TRANS/WP.29/GRPE/2003/5
13 November 2002

PROPOSAL FOR DRAFT AMENDMENTS TO
THE 05 SERIES OF AMENDMENTS TO REGULATION No. 83

(Emissions of pollutants of vehicles)

Transmitted by the expert from France

Condition A of the Type I test

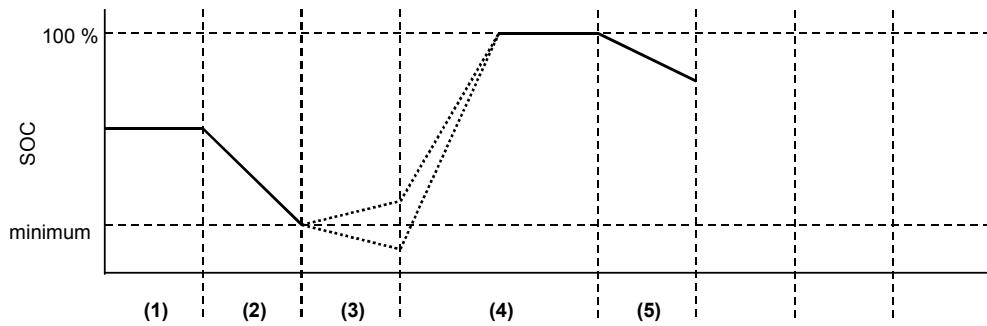
- (1) initial electrical energy/power storage device state of charge
- (2) discharge according to paragraph 3.1.2.1. or 3.2.2.1.
- (3) vehicle conditioning according to paragraph 3.1.2.2. or 3.2.2.2.
- (4) charge during soak according to paragraphs 3.1.2.3. and 3.1.2.4.,
or paragraphs 3.2.2.3. and 3.2.2.4.
- (5) test according to paragraph 3.1.2.5. or 3.2.2.5.

Condition B of the Type I test

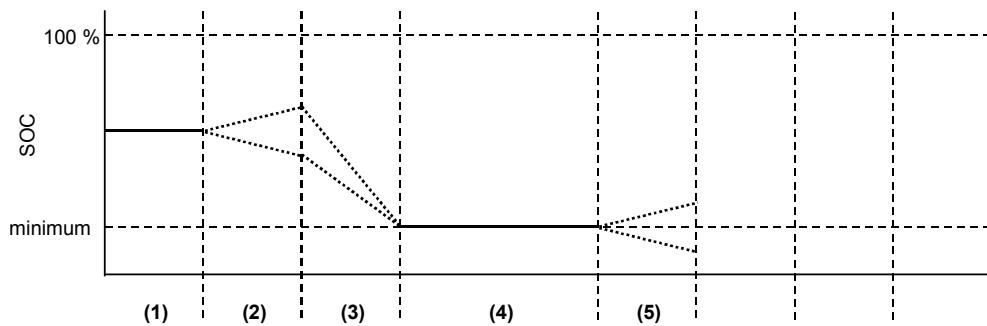
- (1) initial state of charge
- (2) vehicle conditioning according to paragraph 3.1.3.1. or 3.2.3.1.
- (3) discharge according to paragraph 3.1.3.2. or 3.2.3.2.
- (4) soak according to paragraph 3.1.3.3. or 3.2.3.3.
- (5) test according to paragraph 3.1.3.4. or 3.2.3.4.
